Permit Number: 080378

has permission to add second addition floor for bedroom & 2 Bathrooms

AT 59 LAFAYETTE ST

City of Portland, Maine - Building or Use Permit Application

SK-1

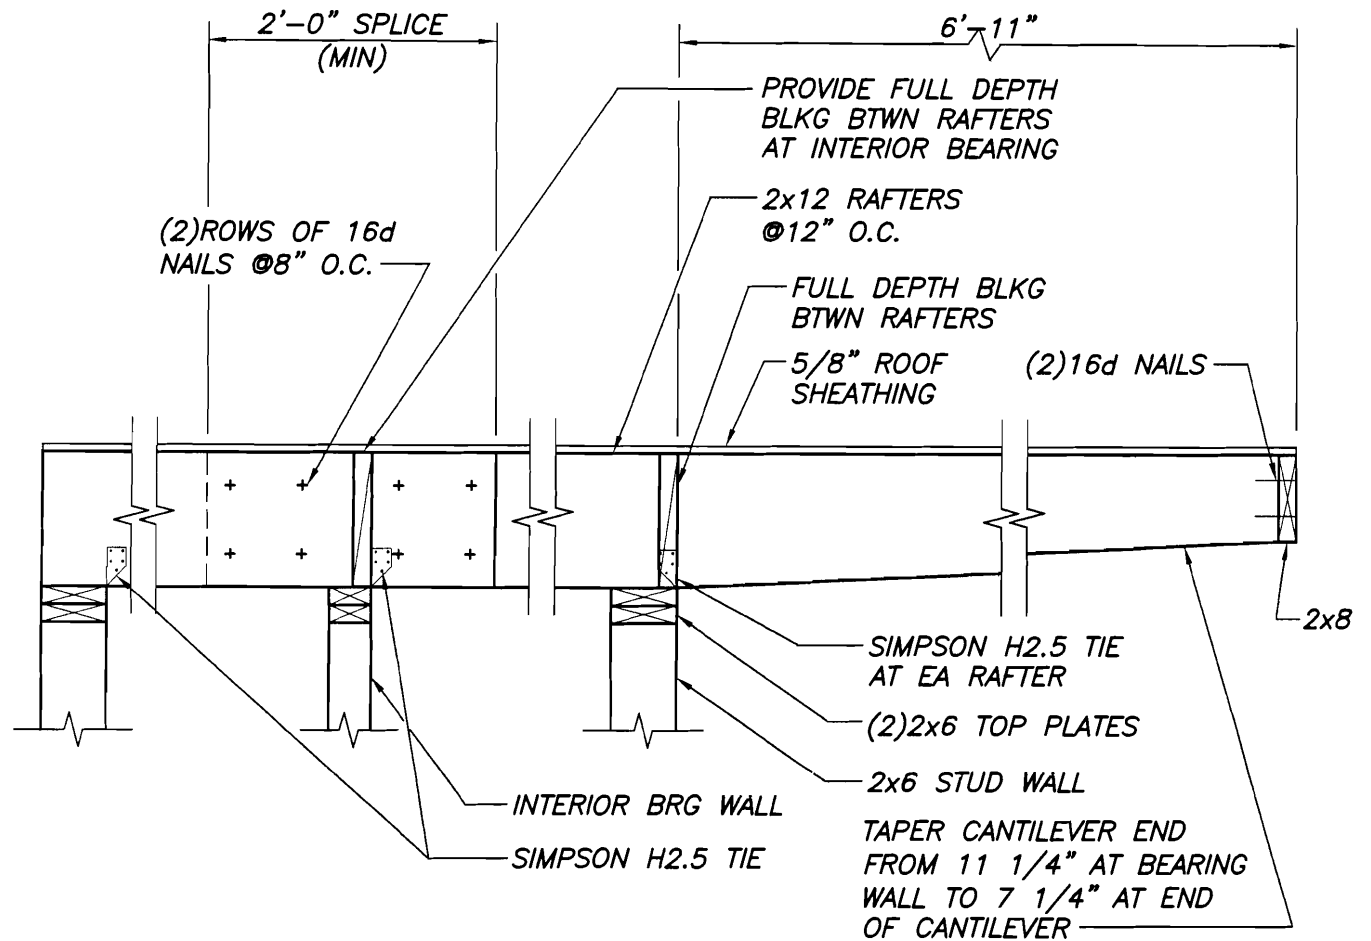
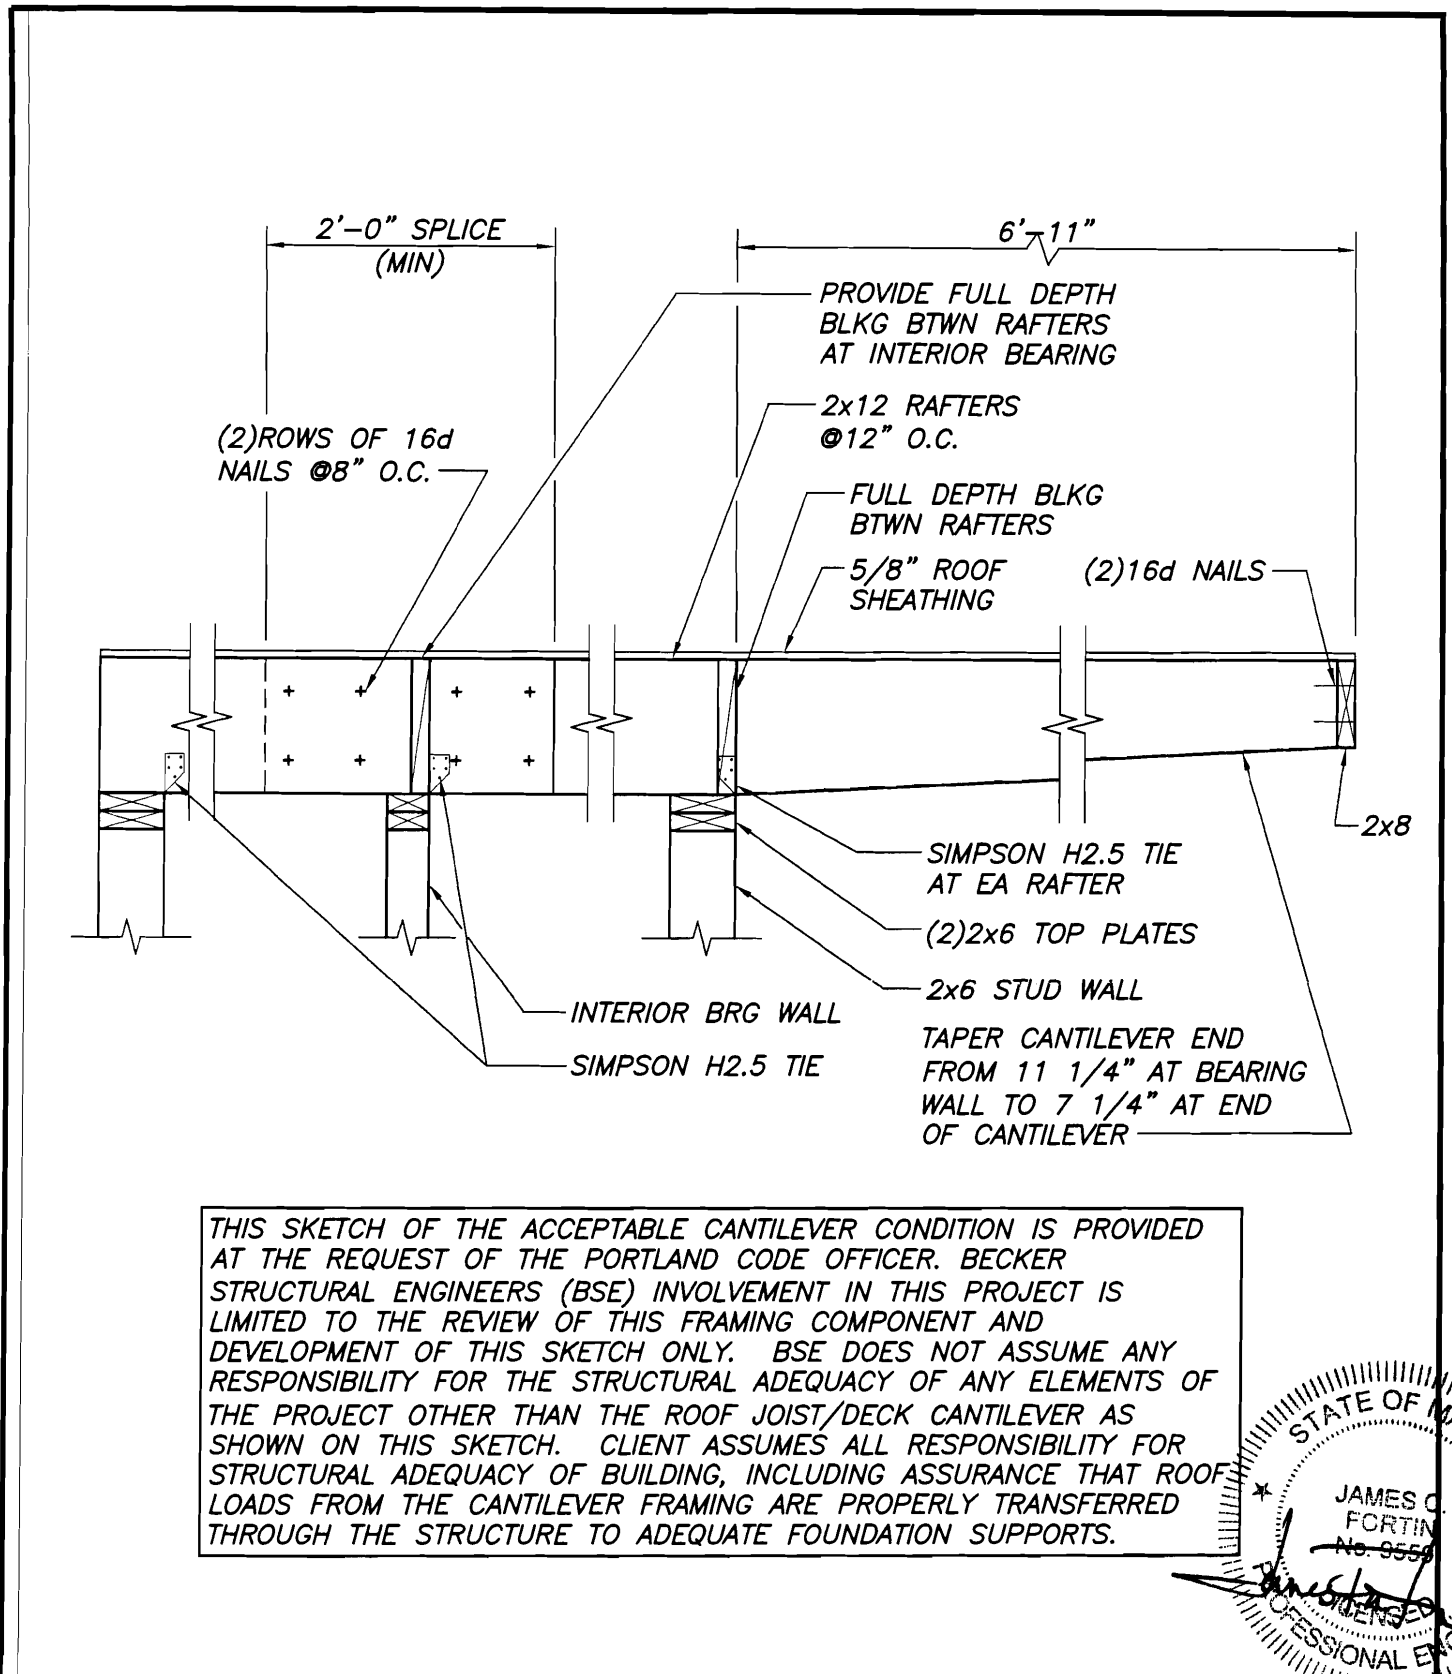
5/21/2008-csh: I have required that the cantalevered roof be designed by a design professional. I called Bob and discussed this .

Pitch, Span, Spacing & Dimension (Table R802.5.1(1) - R 802.5.1(8))	? Not shown	2/12	*	(see skt)
Roof Rafter; Framing & Connections (Section R802.3 & R802.3.1)	2x12 - overhang ripped w/ cut	(soffit) sistered	*	per Beckan STR.
Sheathing; Floor, Wall and roof (Table R503.2.1.1(1))	1/2 CDX w/ Metal Standing Seam siding.			
Fastener Schedule (Table R602.3(1) & (2))	IRC ~ 2003			
Private Garage (Section R309)				
Living Space? (Above or beside)	N/A			
Fire Separation (Section R309.2)				
Opening Protection (Section R309.1)				
Emergency Escape and Rescue Openings (Section R310)	Doors to deck			
Roof Covering (Chapter 9)	24 G. Standing Seam panels.			
Safety Glazing (Section R308)	Foyer? 1st		*	
Attic Access (Section R807)	N/A.			
Chimney Clearances/Fire Blocking (Chap. 10)	Chimney to be removed.			
Header Schedule (Section 502.5(1) & (2))	Not shown	2XB Box Type	*	
Energy Efficiency (N1101.2.1) R-Factors of Walls, Floors, Ceilings, Building Envelope, U-Factor Fenestration	R-19 walls R-40 ceiling. Not shown		*	400 series

THIS SKETCH OF THE ACCEPTABLE CANTILEVER CONDITION IS PROVIDED AT THE REQUEST OF THE PORTLAND CODE OFFICER. BECKER STRUCTURAL ENGINEERS (BSE) INVOLVEMENT IN THIS PROJECT IS LIMITED TO THE REVIEW OF THIS FRAMING COMPONENT AND DEVELOPMENT OF THIS SKETCH ONLY. BSE DOES NOT ASSUME ANY RESPONSIBILITY FOR THE STRUCTURAL ADEQUACY OF ANY ELEMENTS OF THE PROJECT OTHER THAN THE ROOF JOIST/DECK CANTILEVER AS SHOWN ON THIS SKETCH. CLIENT ASSUMES ALL RESPONSIBILITY FOR STRUCTURAL ADEQUACY OF BUILDING, INCLUDING ASSURANCE THAT ROOF LOADS FROM THE CANTILEVER FRAMING ARE PROPERLY TRANSFERRED THROUGH THE STRUCTURE TO ADEQUATE FOUNDATION SUPPORTS.

TYPICAL WALL SECTION

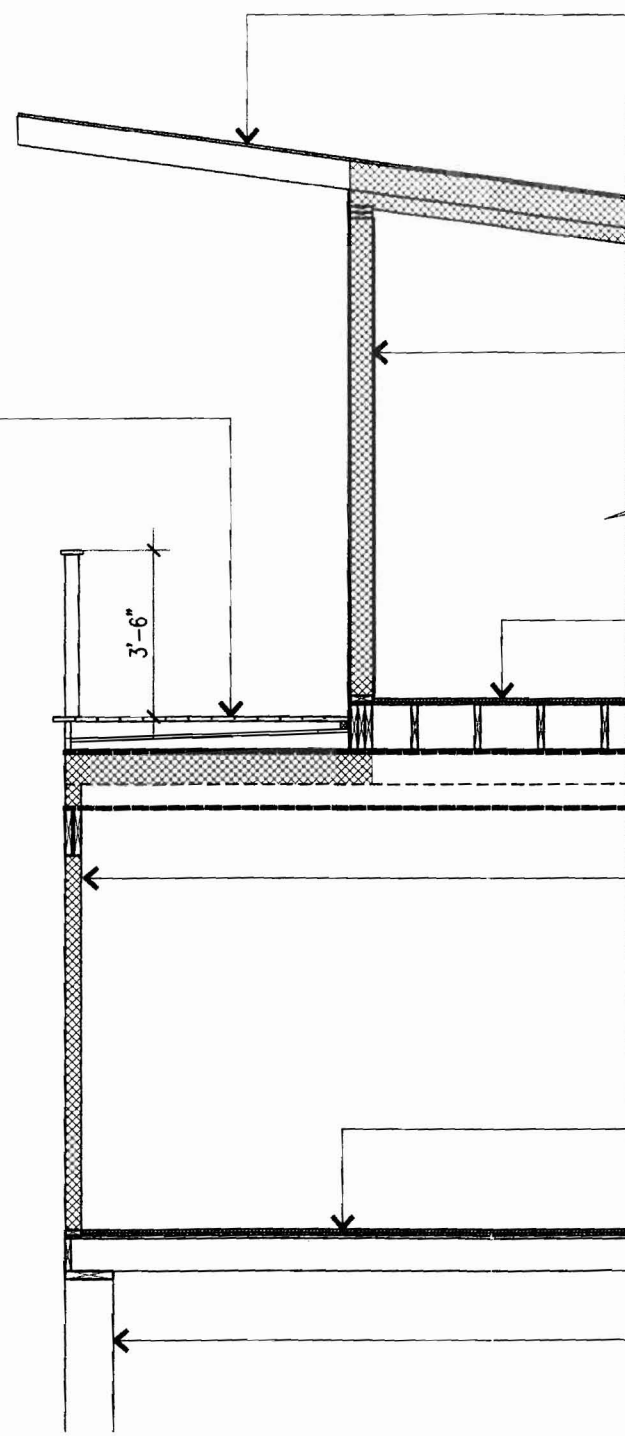
- 1) Fastener schedule per the IRC 2003
- 2) This permit DOES NOT certify the use of the property or building. It only authorizes the construction activities.
- 3) As discussed during the review process, ballusters must be spaced with less than a 4" opening between each.
- 4) Hardwired interconnected battery backup smoke detectors shall be installed in all bedrooms, protecting the bedrooms, and on every level.
- 5) The design load spec sheets for any engineered beam(s) / Trusses must be submitted to this office.
- 6) Permit approved based on the plans submitted and reviewed w/owner/contractor, with additional information as agreed on and as noted on plans.
- 7) Separate permits are required for any electrical, plumbing, or HVAC systems. Separate plans may need to be submitted for approval as a part of this process.

BALCONY DECK SYSTEM:
 5/4 MERANTI DECKING BOARDS
 4 X 4 X 42" HIGH RAILING WITH 1" SQUARE
 BALUSTERS @ 4" O.C.
 2 X 6 PRESSURE TREATED SLEEPER JOISTS
 @ 16" O.C.
 EPDM MEMBRANE
 3/4" ADVANTEC PLYWOOD SUBFLOOR
